Zero- and Negative-Emissions Fossil-Fired Power Plants Using Post-Combustion CO₂ Capture

Tianyu Gao* and Abhoyjit Bhowm

Meeting on Net Zero Flexible Power: High Capture Rate
Philadelphia, PA
June 6-7, 2024

CO₂ Capture Cost at Different Capture Rates – Coal-fired plants

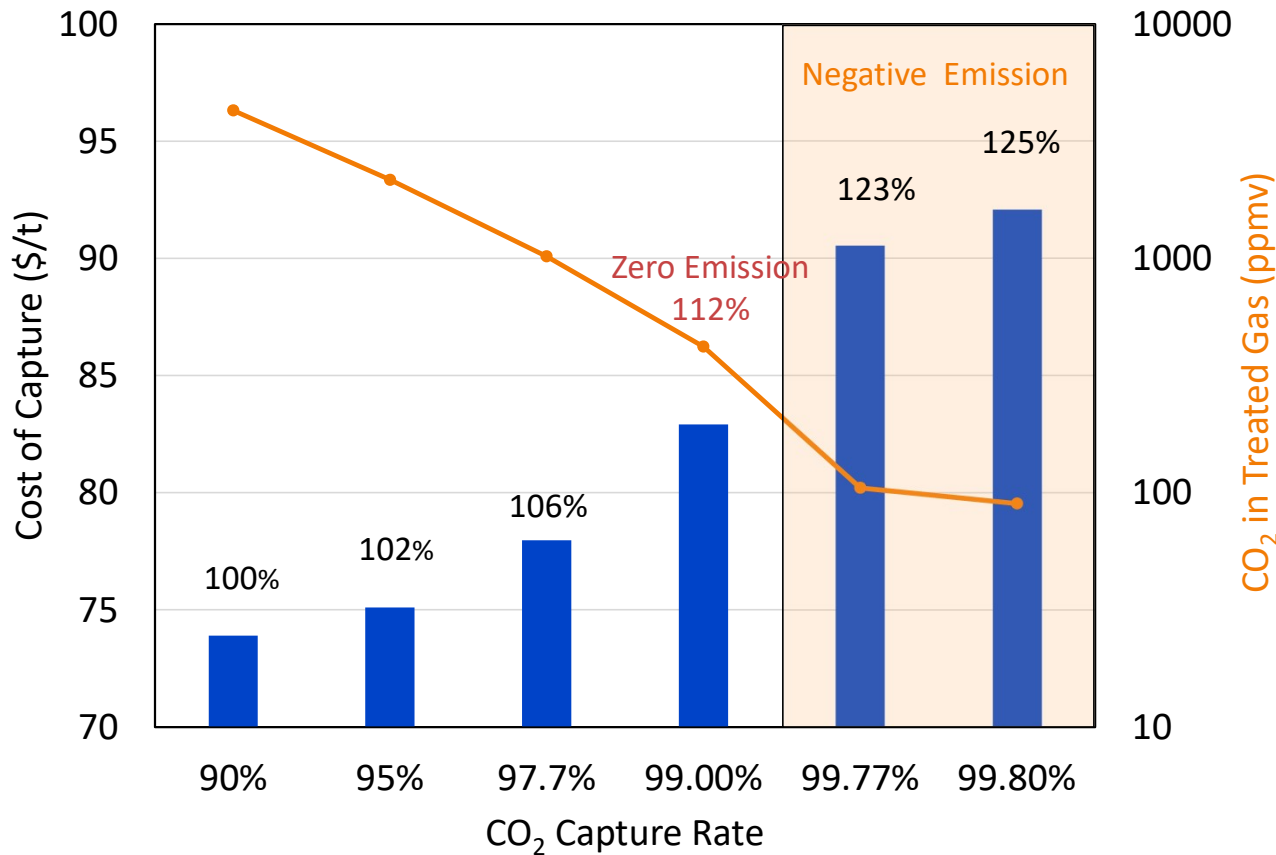
Be sure to point out negative emissions too and what that means.

CO₂ Capture Cost at Different Capture Rates – NGCC

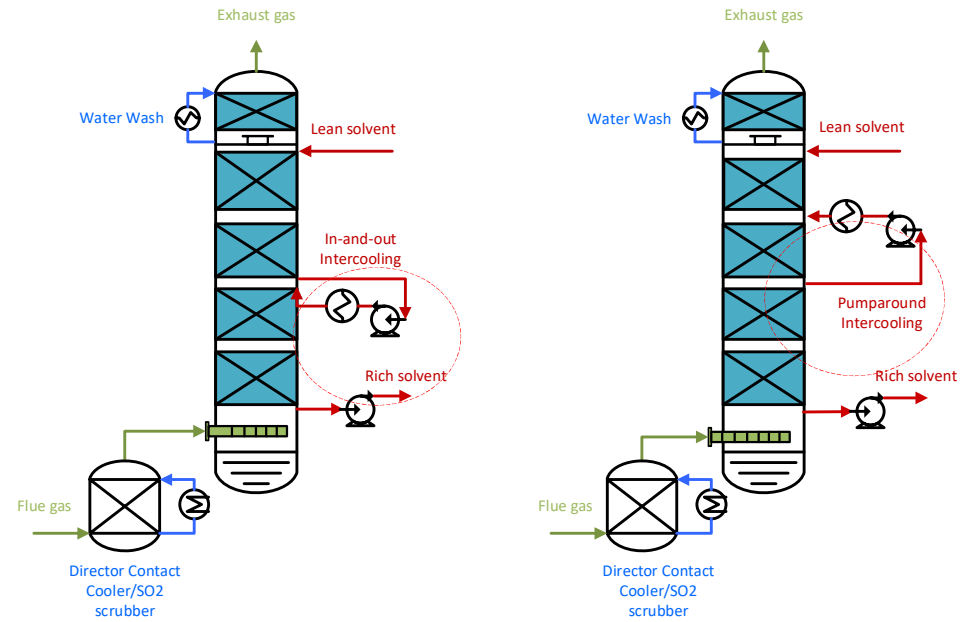
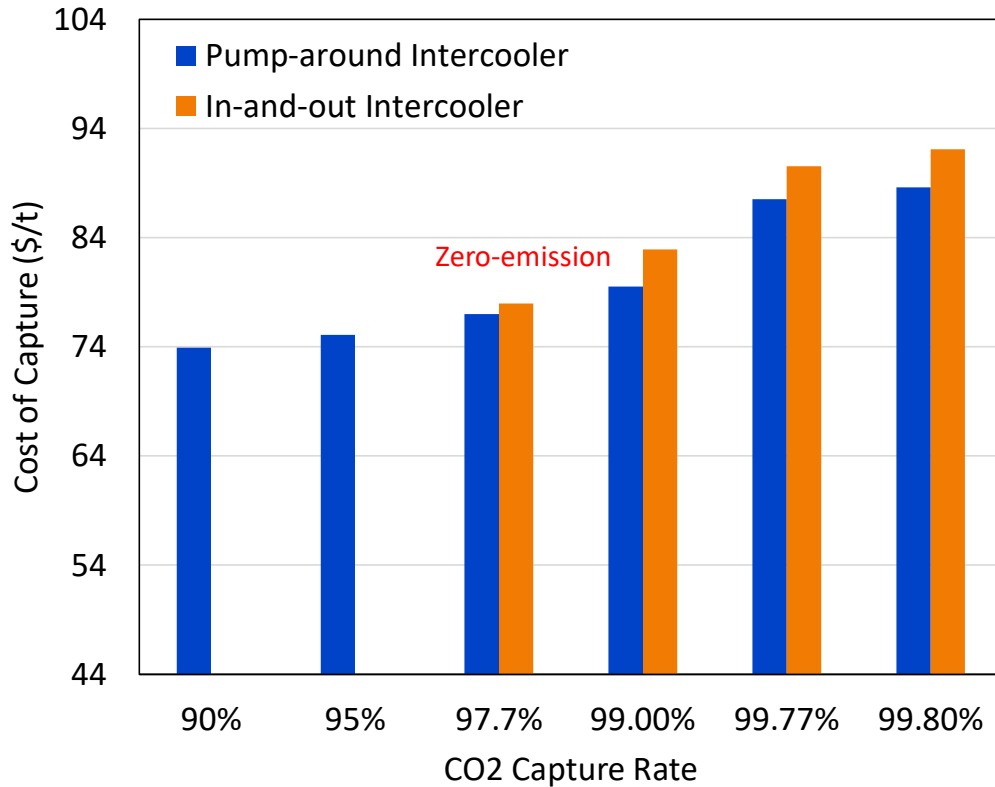
BA0 Provide numbers for highlighted text
Bhown, Abhoyjit, 2024-06-03T21:38:10.225
